**International Uranium (USA)
Corporation**

**SOURCE MATERIALS LICENSE
SUA-1358, DOCKET No. 40-8681**

**Additional Clarifications to
White Mesa Mill Reclamation Plan**

April 15, 1999

SECTION E - 6

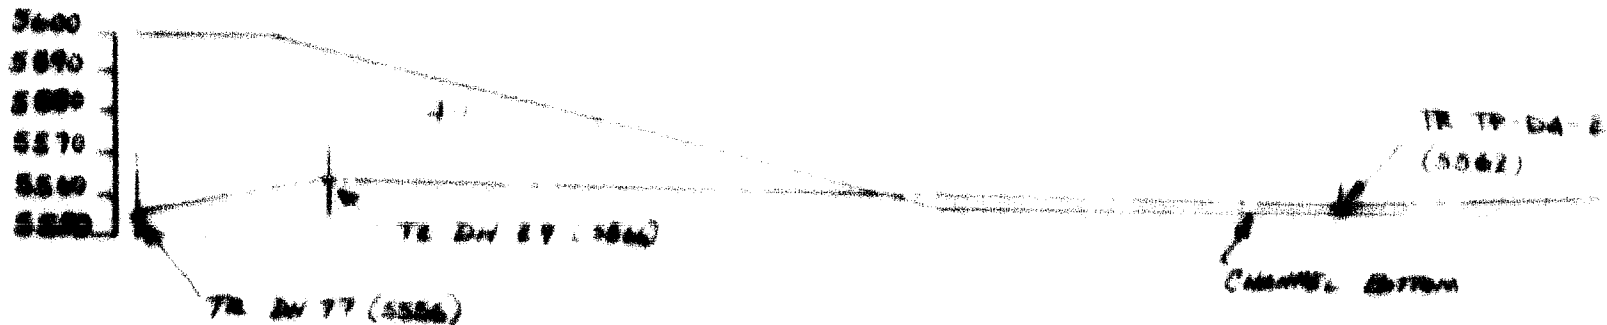
- 4) Sections D and E to Figure A-5.1-1, details the cross sections to the breach of Cell 4A Dike.
- 5) Revised Rational Method Calculation of PMF Peak Discharge, Velocity, Depth, and Scour through Cell 4A Breach, with breach widened to 200 feet.
- 6) Revised details to the Rock Apron at Toe of Cell Outslope. This drawing has been previously submitted to the NRC in response to Question 19 of the August 28, 1998 Submittal to NRC.
- 7) Results of a rerun of the Radon Emanation Calculations to take into account revisions to inconsistent variables and more conservative approach to the assumptions used in cover design, as per NRC staff suggestions,

ROCK APRON AT TOE OF CELL OUTSLOPE

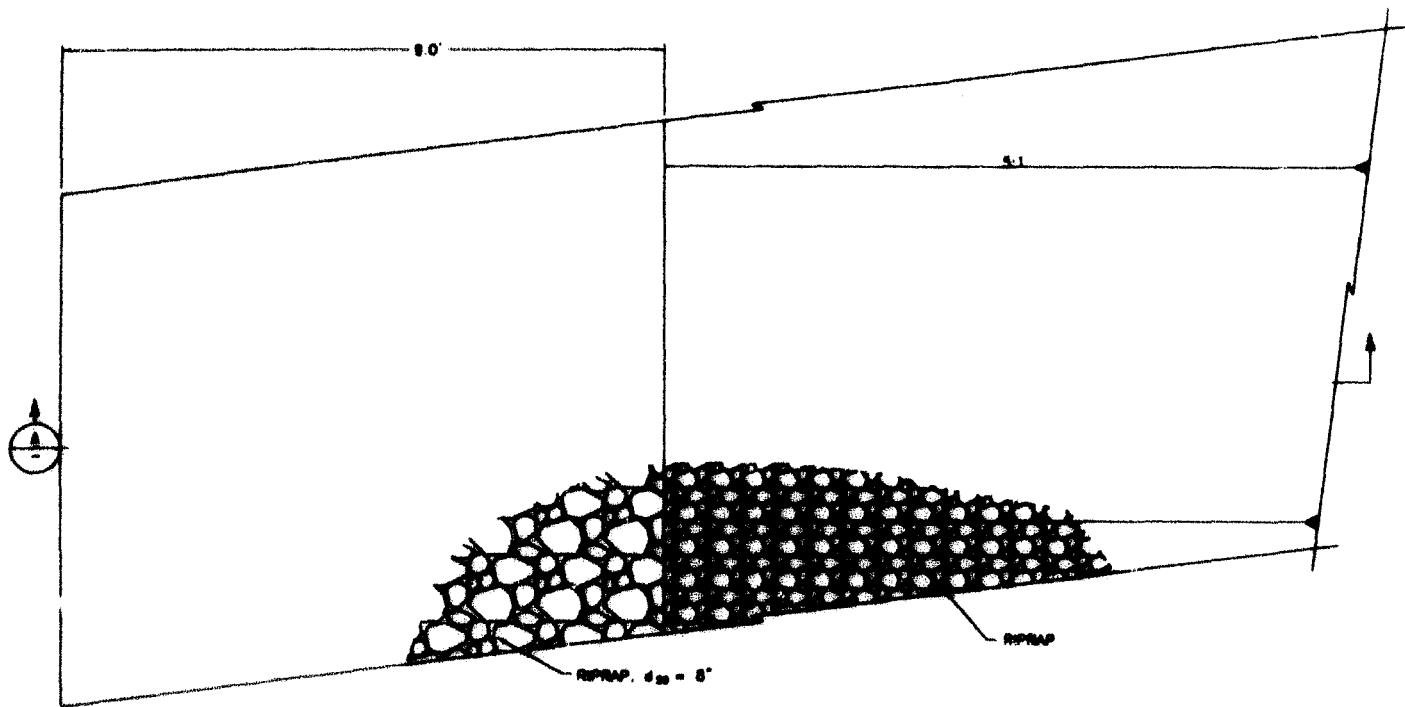
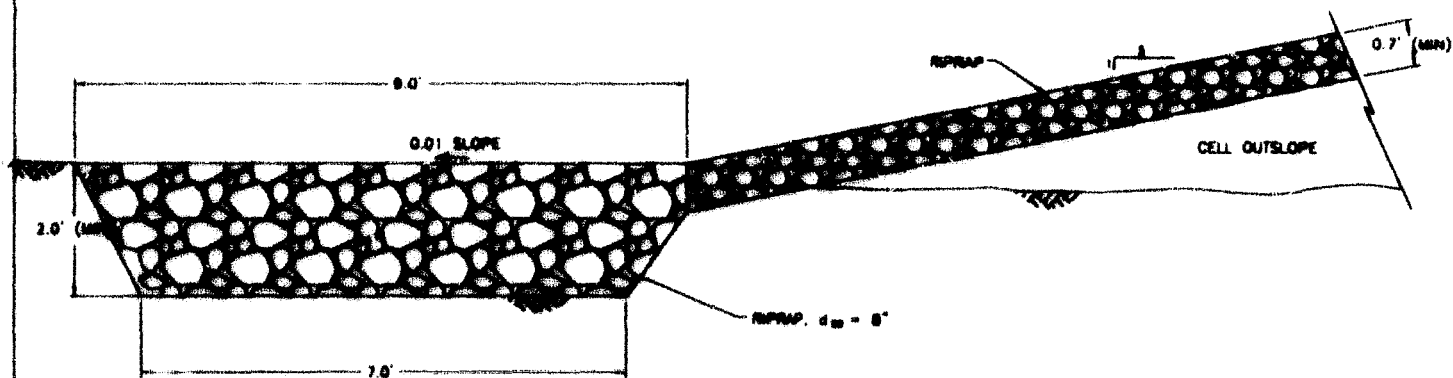
Location	D_{50} Size	D_{100} Size	Layer Thickness
Top Surface	0.3"	0.6"	6"
Slope Surface	3.5"	7"	8"
Toe Apron	6.4"	12"	24"
